Commonwealth Edison
1400 Opus Place
Downers Grove, Illinois 60515

January 15, 1992

Subject: NRC Evaluation of the Commonwealth Edison Response to Generic Letter 87-02, Supplement 1, "Verification of Seismic Adequacy of Mechanical and Electrical Equipment in Operating Reactors", SQUG Resolution of USI A-46.

ADDITIONAL INFORMATION ON
IN-STRUCTURE RESPONSE SPECTRA
FOR DRESDEN - UNITS 2 & 3
AND QUAD CITIES - UNITS 1 & 2

FIGURE 1 ACCELERATION RESPONSE SPECTRUM, LOG-LOG SCALE

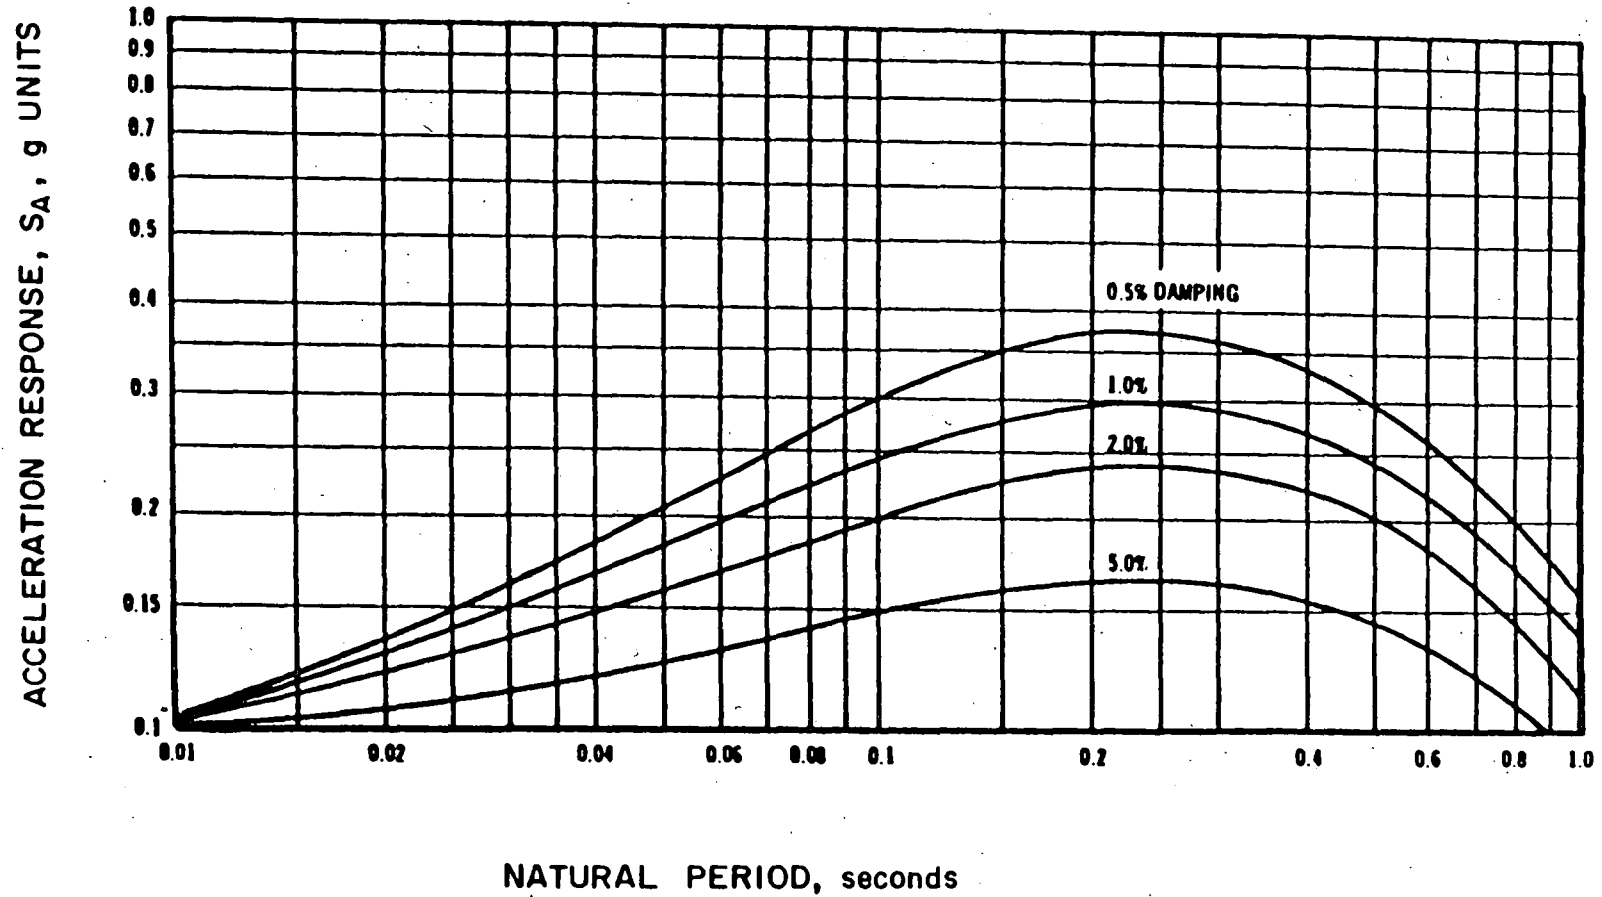
The NRC safety evaluation found that the CECo responses regarding the ISRS for Zion station, and the implementation schedules for the three USI A-46 CECo plants, Dresden, Quad Cities and Zion stations are acceptable. However, the NRC staff stated that the response was unclear as to whether CECo intends to use both the SQUG commitments and the implementation guidance. The staff did interpret our response as a commitment to the entire GIP-2 including both the SQUG commitments and the implementation guidance, and therefore, considered it acceptable. In the original submittal CECo committed to the GIP, in its entirety, including clarifications, interpretations, and exceptions identified in SSER-2 as clarified in the reference (1) August 21, 1992 letter with no exceptions.

The site specific SSE spectrum anchored at 0.13g has been approved for Dresden - Unit 2 under the Systematic Evaluation Program (SEP) by the NRC. However, for the resolution of USI A-46, Commonwealth Edison Company (CECo) will use the conservative design basis SSE ground response spectrum anchored at 0.2g. The Dresden design-basis SSE ground response spectra are smoothed Housner-type spectra. Figure 1 shows Housner-type response spectra, for various damping values, anchored to 0.10g PGA. The 5% damped ground response spectrum, anchored to 0.20g PGA, will be used for A-46 work on Dresden - Units 2 & 3. At Quad Cities - Units 1 & 2, the ground spectrum to be used for A-46 work will be of the same shape as for Dresden (shown in Figure 1); however, it will be scaled up by anchoring at 0.24g.

FIGURE 3.

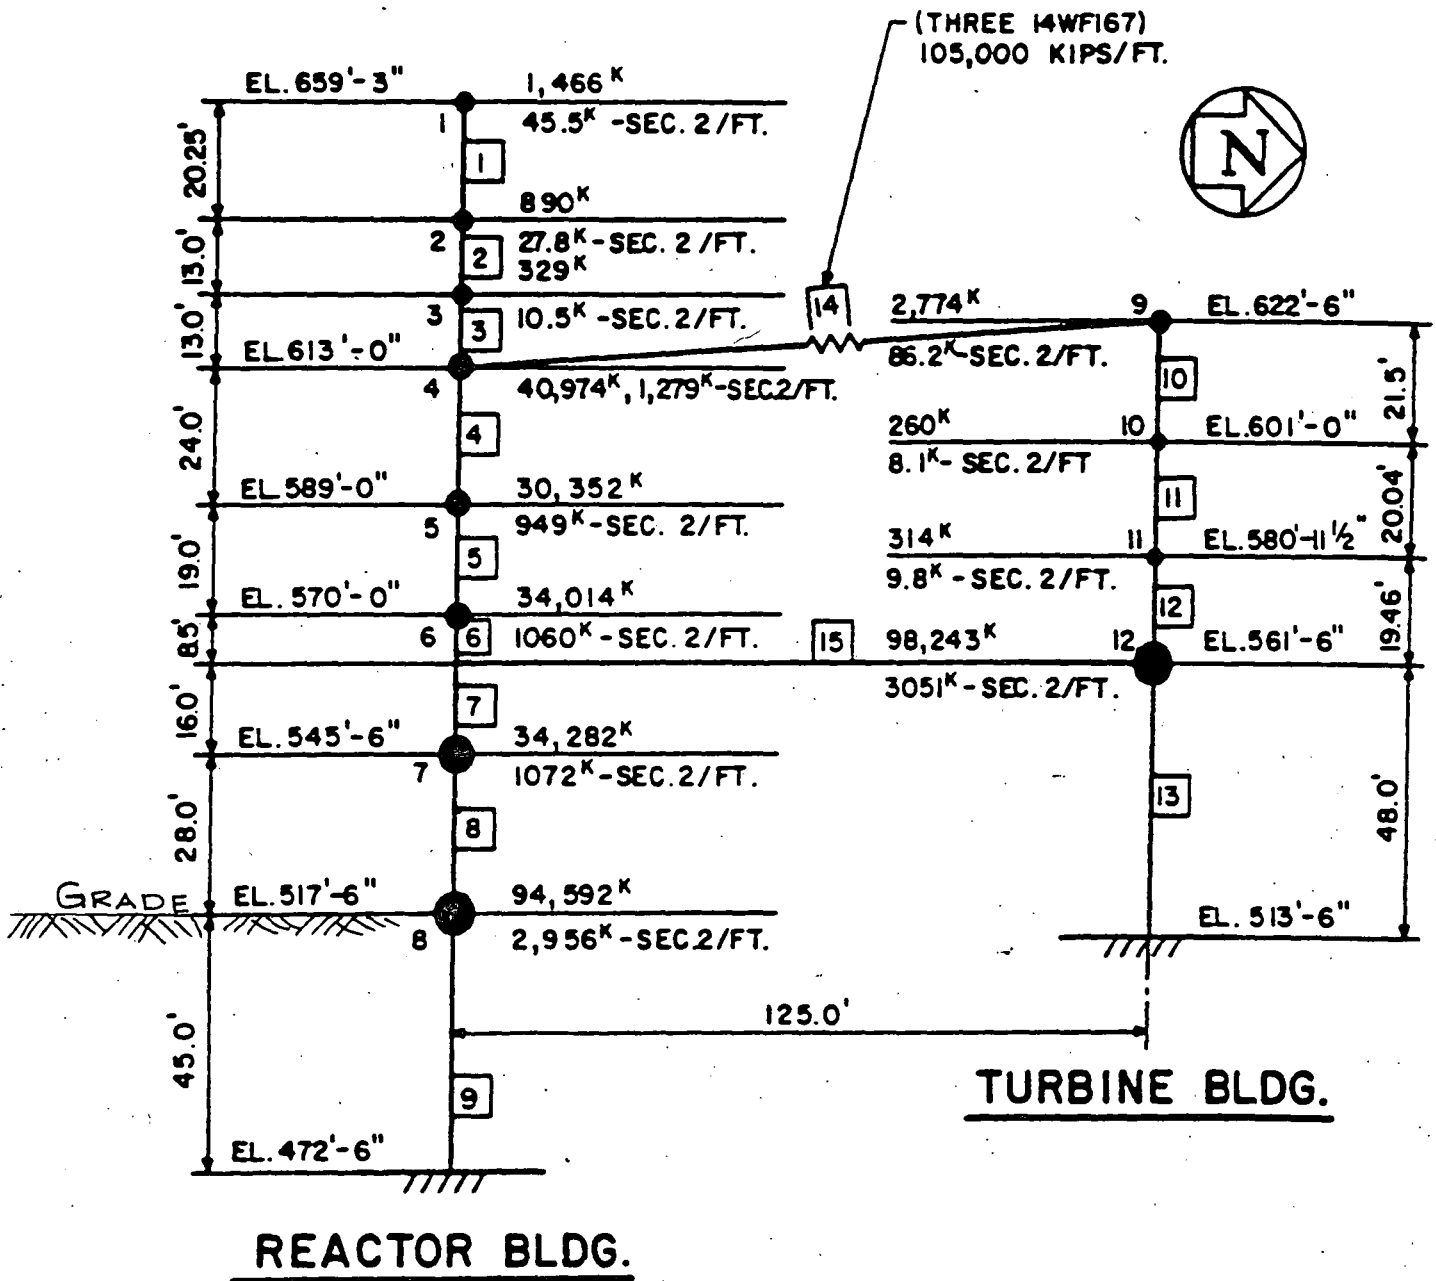
The NRC requested additional information regarding the Dresden and Quad Cities in-structure response spectra. This information is enclosed in the Attachment to this letter.

The building models used for Dresden - Unit 2 & 3 ISRS generation are shown in Figures 3 & 4 for N-S and E-W directions, respectively. The mass and stiffness properties are also shown in the above figures.

The Quad Cities - Units 1 & 2 were designed as sister units to Dresden - Units 2 & 3 by the same NSSS supplier, using the same architect/engineer. A review of the plants structural drawings for parameters which affect the seismic models (i.e., mass and stiffness) has confirmed that the two plants are quite similar in terms of their seismic behavior. The review included comparison of building dimensions, major floor slab elevations, plan dimensions, thickness of slabs and concrete walls, and steel bracing dimensions which constitute to the horizontal stiffness of the buildings. Based upon this comparison between the two plant's seismic building characteristics, CECo has concluded that the building model used at Dresden is acceptable to be used for Quad Cities.

For the dynamic response analysis, an equivalent lumped mass model was developed for the buildings in each direction. In the N-S direction, the reactor and turbine building models are connected at two points: (1) at about 44 feet above grade, representing the operating floor of the turbine building; and (2) at about 105 feet above grade, representing the roof of the turbine building. In the E-W direction, the two building models are connected at one point only, at about 44 feet above grade representing the operating floor of the turbine building. Each story level mass represents the mass of concrete and equipment at each floor and the tributary mass of the equipment and concrete walls between adjacent floors. The top story masses are similarly developed but include the tributary mass of the walls, steel frame, and the mechanical equipment of the story. The average area and moment of inertia of the structural elements between floors is used to determine the stiffness characteristics between masses.

The lines interconnecting the masses in Figure 3 represent weightless N-S springs having a stiffness equal to the stiffness of the actual structure in that direction. Likewise, the lines in Figure 4 represent E-W springs having a stiffness equal to the stiffness of the actual structure in that direction.
